PIC16C63A Rev. A Silicon Errata Sheet

The PIC16C63A (Rev. A) parts you have received conform functionally to the Device Data Sheet (DS30605A), except for the anomalies described below.

FIGURE 1: $\overline{\text{MCLR}}$ EXTERNAL CIRCUIT

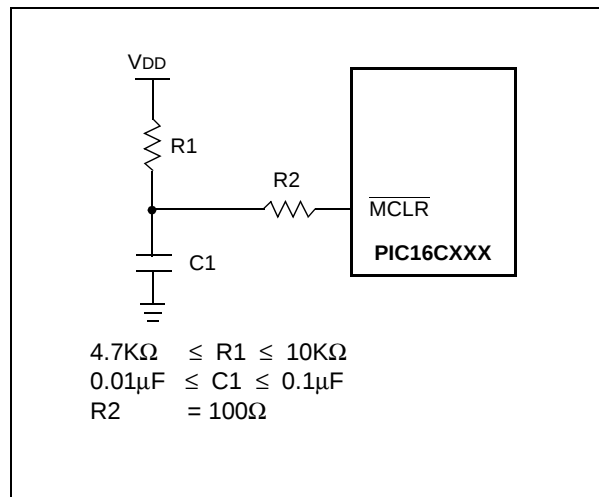
The minimum specification for the $\overline{\text{MCLR}}$ must be met in order to RESET the PIC16CXXX. If a $\overline{\text{MCLR}}$ pulse occurs that is less than the minimum specification (parameter #30), improper device operation can occur.

If the minimum specification cannot be met, then an external circuit must be used to insure that any pulse width less than the specification will be filtered before it reaches the $\overline{\text{MCLR}}$ pin.

A possible circuit is shown in Figure 1. Proper design validation needs to be done to ensure desired operation over the applications operating conditions

Figure 2: Wake-up from Sleep

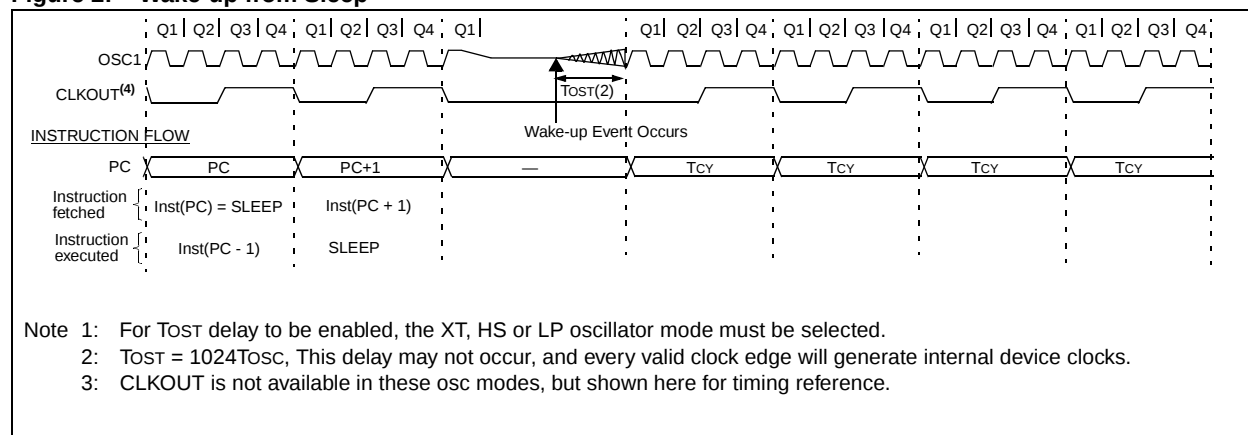
The Oscillator Start-up Timer (T_{OST}) delay may not occur when the device wakes-up from sleep.

Figure 2 shows the start-up of the crystal after the event that causes the device to wake up from sleep mode (as specified in device data sheet). The start-up time (T_{OST}) may not occur.

After the SLEEP instruction, do a software delay of 256 T_{CY} (same as 1024 T_{OSC}). At the Reset and Interrupt vector addresses, test to see if the device woke from sleep (the $\overline{TO}$ and $\overline{PD}$ bits), and if the device did wake from sleep, ensure that the total cycle delay is 256 T_{CY} .

Figure 3: PIC16CXXX Voltage-Frequency Graph

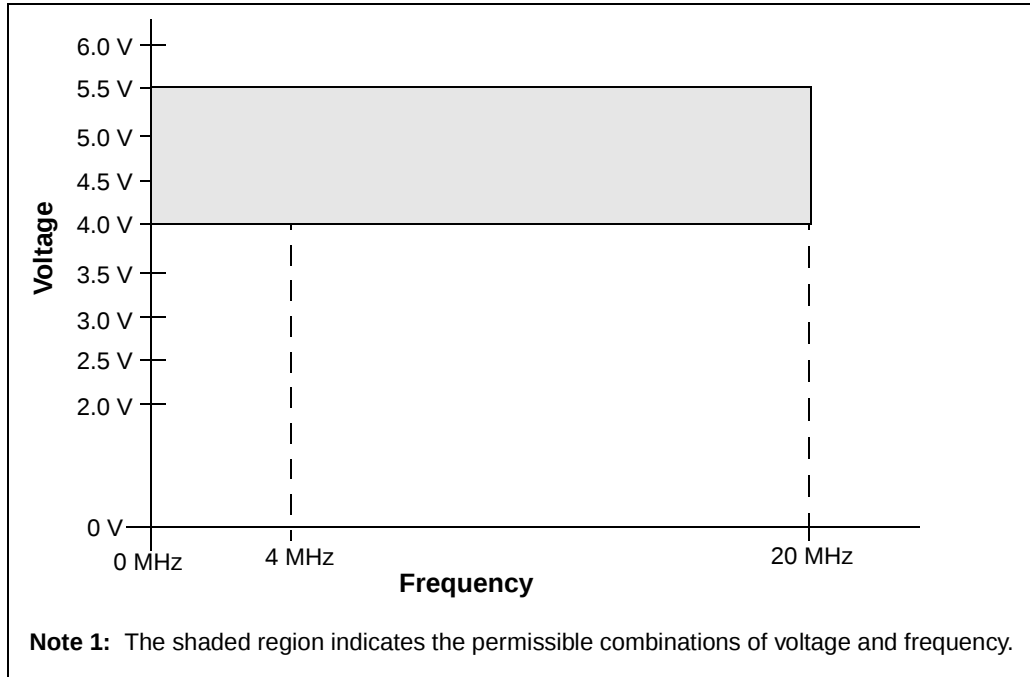
1. Figure 3 and Figure 4 are additions to the data sheet to show the area of operation. These figures replace the Cross Reference of Device Specs for Oscillator Modes Table in the Electrical Specification section.

Figure 3 shows the voltage vs. frequency operation for the PIC16CXXX devices. Devices marked with a "-04" operate up to 4 MHz, while devices marked with a "-20" operate up to 20 MHz. The entire shaded region is the valid operating region.

Figure 4: PIC16LCXXX Voltage-Frequency Graph

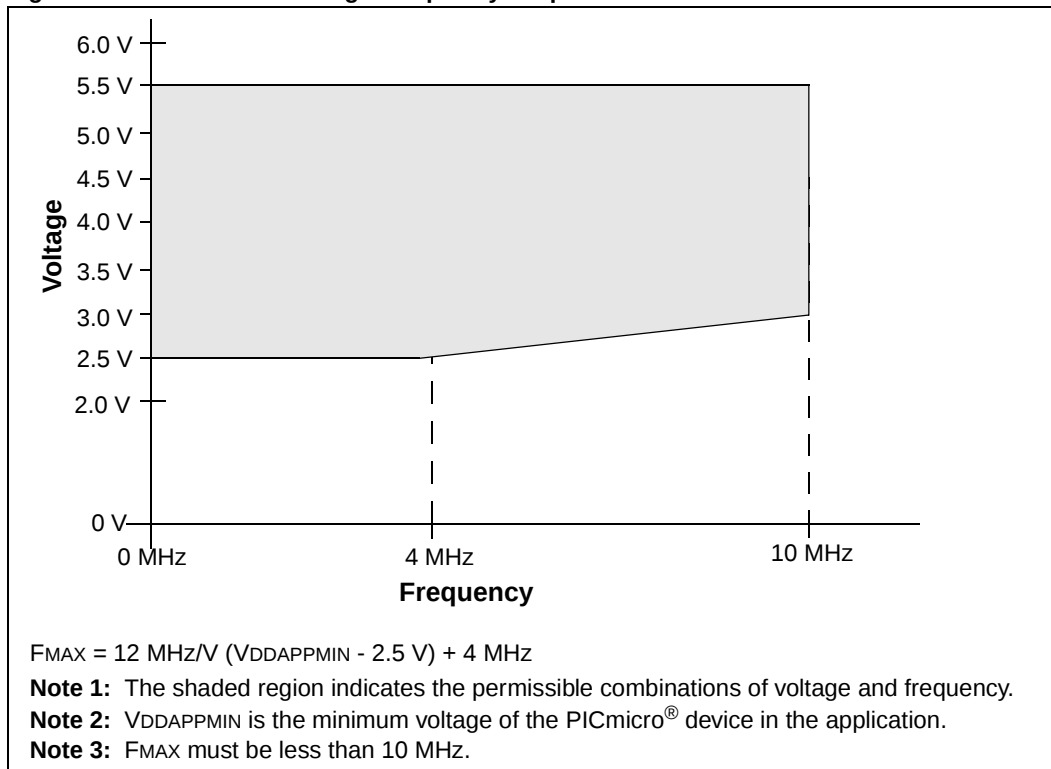
Figure 4 shows the voltage vs. frequency operation for the PIC16LCXXX devices. The devices marked with a "-04" operate up to 4 MHz at the minimum supplied voltage. The devices also operate at a higher frequency (10 MHz) and at a higher voltage (3V). The entire shaded region is the valid operating region.
